**Northrop Grumman Corporation
Defense Systems Sector
Alliant Techsystems Operations LLC
Allegany Ballistics Laboratory
210 State Route 956
Rocket Center WV 26726**

Request for Amendment to Materials License Number SUB-1440 Docket No. 040-08850

This letter is a request to amend the subject materials license. The following modifications should be made to the license as a result of the following changes: **Addition of new 30/50 mm DU projectile assembly operation in building 376.**

Building 376 Med. Cal.

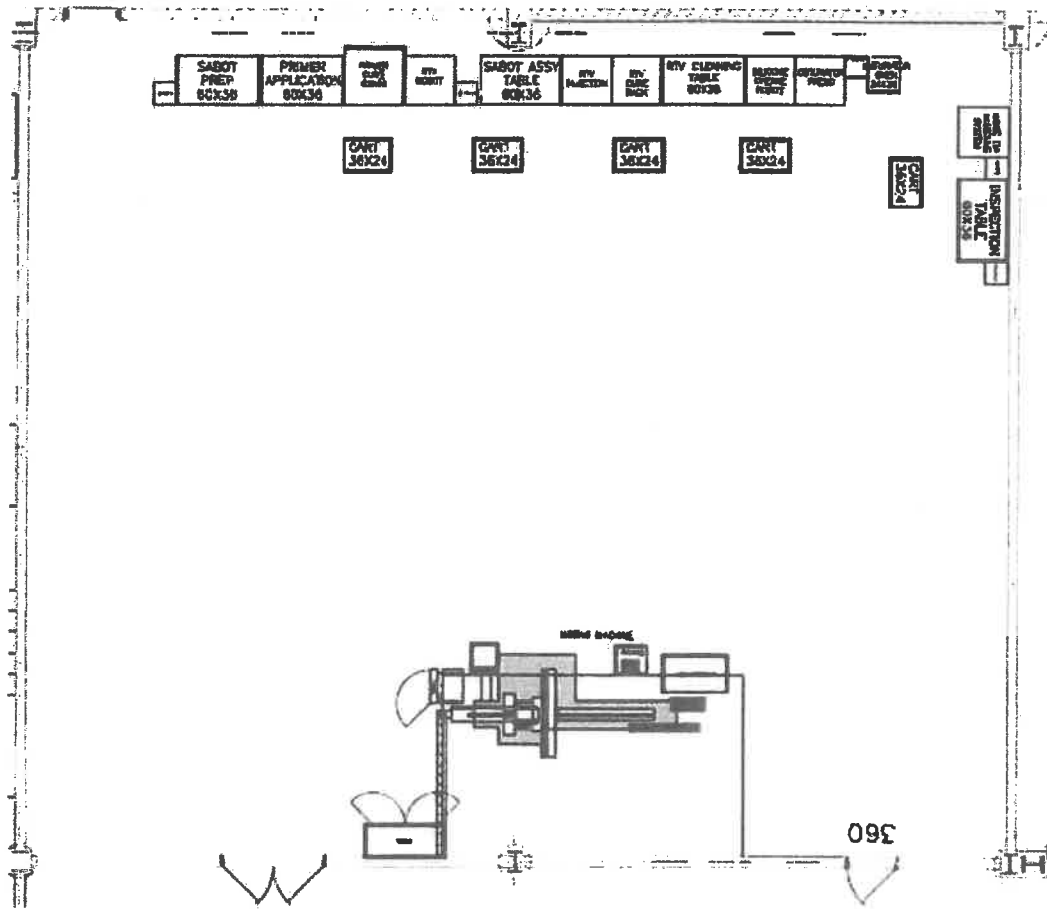
Form 313 Section 9. Building 376 is requested to be added as location of authorized, licensed operations.

The addition of this building is to support the Armor Piercing Sabot Subassembly for use in 30x173mm APFSDS-T (XM1170) cartridges and 50mm x 228 (XM1203) cartridges. The Alliant Techsystems Operations (ATO) site-wide maximum amount of authorized RAM will not change. Authorized uses requested are possession, storage, distribution, manufacturing and assembly into military munitions, quality assurance testing, and disassembly of munitions. Prohibitions include depleted uranium cutting, grinding, machining, and test firing of depleted uranium munitions.
